Lake Shannon Dam
Dam Identification No. 621 | Tyrone Township, Livingston
County, Michigan

NATIONAL DAM SAFETY PROGRAM INSPECTION REPORT

October 18, 2022

PHOTO 19

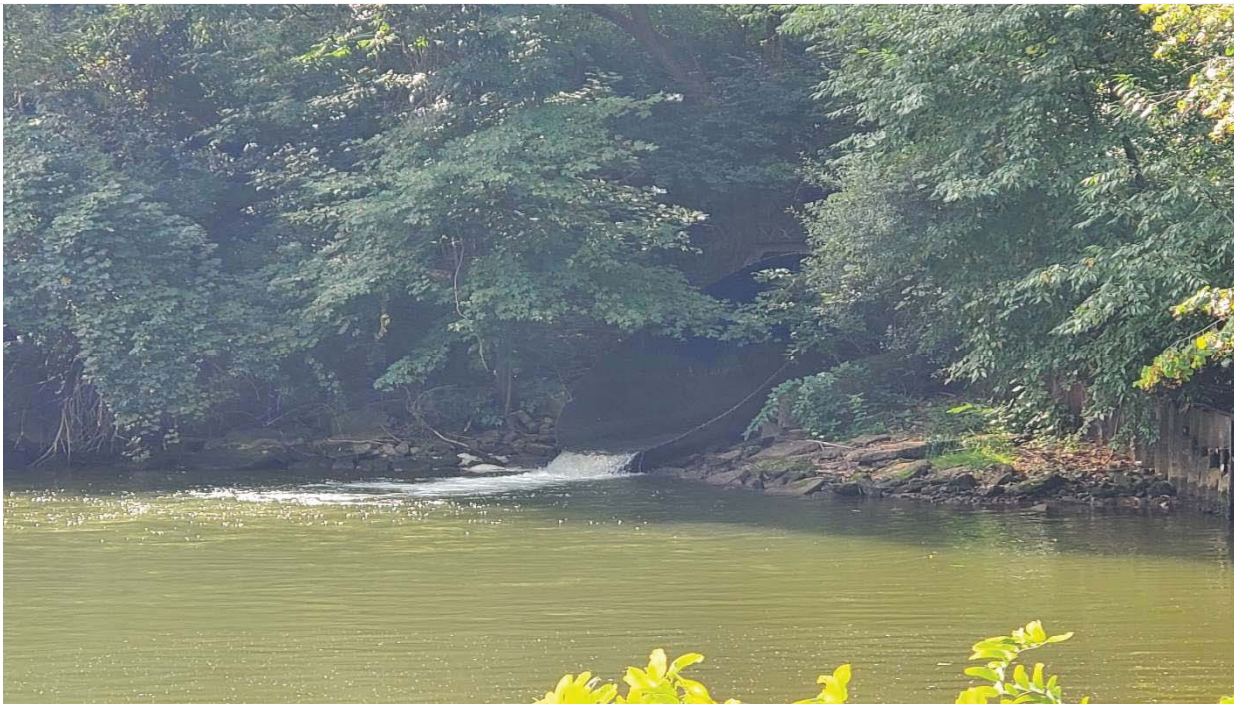
7. Add riprap on the downstream outlet slope around the 96-inch outlet.

PHOTO 33

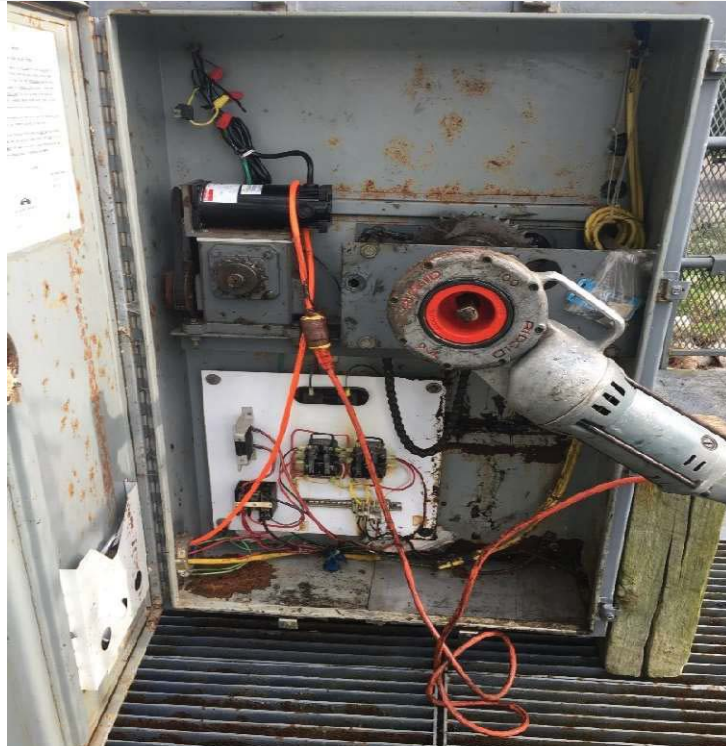
3. The electrical cabinets need to be updated to meet current electrical standards. The use of plug-in extension cords within the cabinets is not in line with electric codes. Section 400.8(1) of the National Electric Code (NEC) does not permit flexible cords and cables to be used as a substitute for permanent wiring of a structure. Currently, the electric box on land has three extension cords plugged into a 4-outlet box. One extension cord extends through the buried conduit to the gate structure. At the gate structure control box, the extension cord is plugged into the electric cord for the power drive unit. The power drive should be plugged directly into a hard-wired outlet box, rated for minimum 15 amps (20 amps preferred).
